Georges River Local Planning Panel

LPP031-23

LPP Report No	LPP031-23	Development Application No	MOD2022/0098
Site Address & Ward Locality	248 Railway Parade Kogarah Kogarah Bay Ward		
Proposed Development	Modification Application MOD2022/0098 involving façade amendments, changes in openings and to balconies, internal alterations including relocating and reconfiguration of suites and floor layout to development consent REV2020/0013 for site remediation, demolition works and construction of a mixed use building containing 3 levels of basement car parking, ground floor commercial and 5 levels of boarding house accommodating 42 rooms inclusive of the caretakers room at 248 Railway Parade, Kogarah		
Owners	Mr and Ms Toskas		
Applicant	Moderinn Pty Ltd		
Planner/Architect	Planning Direction Pty Ltd, Moderinn Pty Ltd		
Date Of Lodgement	6/06/2022		
Submissions	One (1) to the original notification, the plans the subject of this report were not notified.

1. This report has been prepared following the deferral of the subject Modification Application MOD2022/0098 by the Local Planning Panel (the Panel) at its meeting of 17 August 2023. The Modification Application the subject of the deferr

Figure 3: New amended Level 5 floor plan with common areas and manager's suite on the northern end.

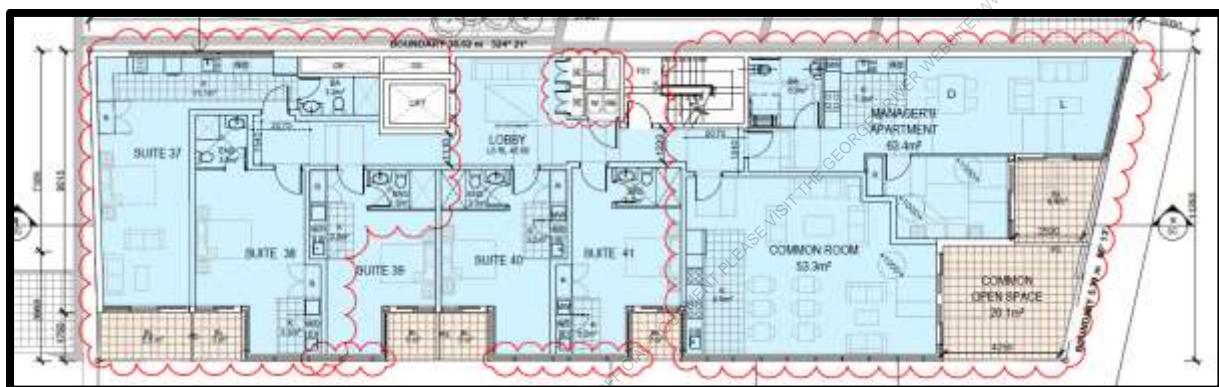
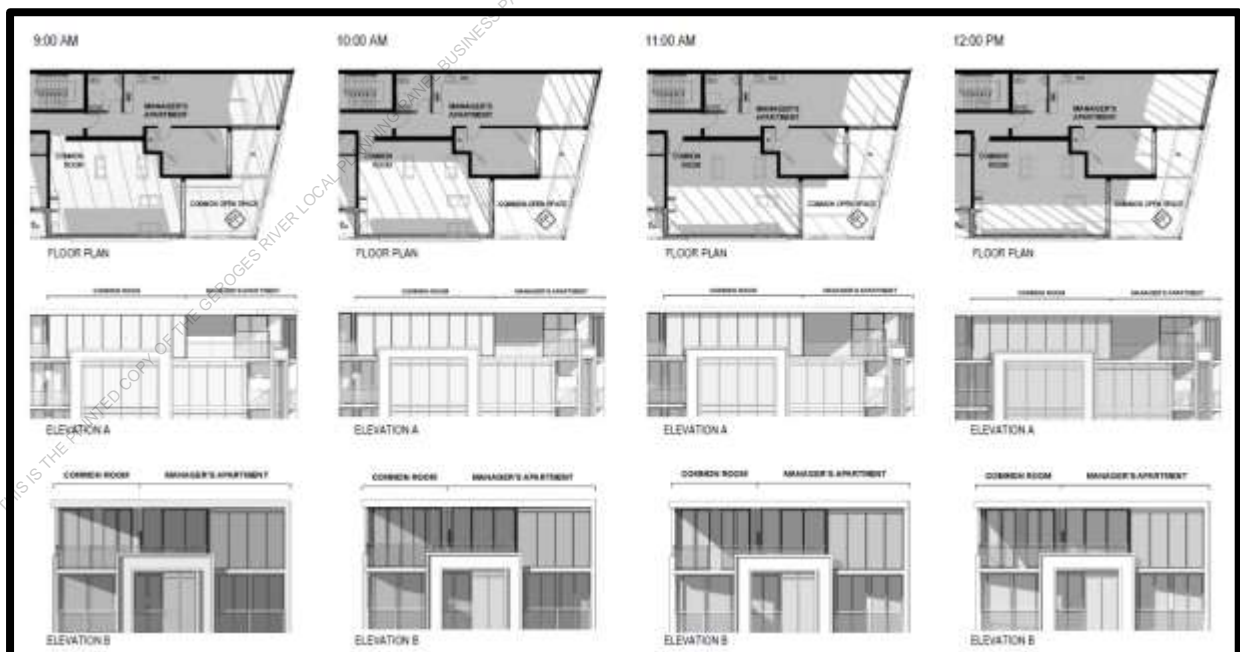
Modification Application No. MOD2022/0098 involving façade amendments, changes in openings and to balconies, internal alterations including relocating and reconfiguration of suites and floor layout to development consent REV2020/0013 for site remediation, demolition works and construction of a mixed use building containing 3 levels of basement car parking, ground floor commercial and 5 levels of boarding house accommodating 42 rooms inclusive of the caretakers room for the Lot 48 at DP2013, known as 248 Railway Parade, Kogarah, is deferred. The Panel invites the applicant to submit amended detail as follows:

- i. *The manager's suite, the communal room and communal open space are to be relocated to the northern part of level 5 of the development to ensure that these spaces receive the required solar access being 3 hours between 9am and 3pm mid winter. The floor plate of this level is to be reconfigured accordingly to accommodate this design change.*

LPP Meeting Minute	Applicant's Submission
<i>The manager's suite, the communal room and communal open space are to be relocated to the northern part of level 5 of the development to ensure that these spaces receive the required solar access being 3 hours between 9am and 3pm mid winter. The floor plate of this level is to be reconfigured accordingly to accommodate this design change.</i>	Amended architectural plans were submitted.
Comment The amended architectural plans were assessed and found to be satisfactory. The floor plate for level 5 has been amended by relocating the manager's suite, communal room and communal open space to the northern end of the building. The relocation of manager's suite, communal room and communal open space results in the new layout being compliant in terms of the minimum solar access requirements. The deferred item has been satisfied by the revised plans.

(2) The following are non-discretionary development standards in relation to the carrying out of development to which this Division applies- ...(e) at least 3 hours of direct solar access provided between 9am and 3pm at mid-winter in at least 1 communal living area,	The amended plans submitted to address the deferral of the application relocates the communal living area from the southern end of level 5 to the northern end level 5. Following the redesign, the communal living area now enjoys greater than 3 hours of direct solar access during	Yes
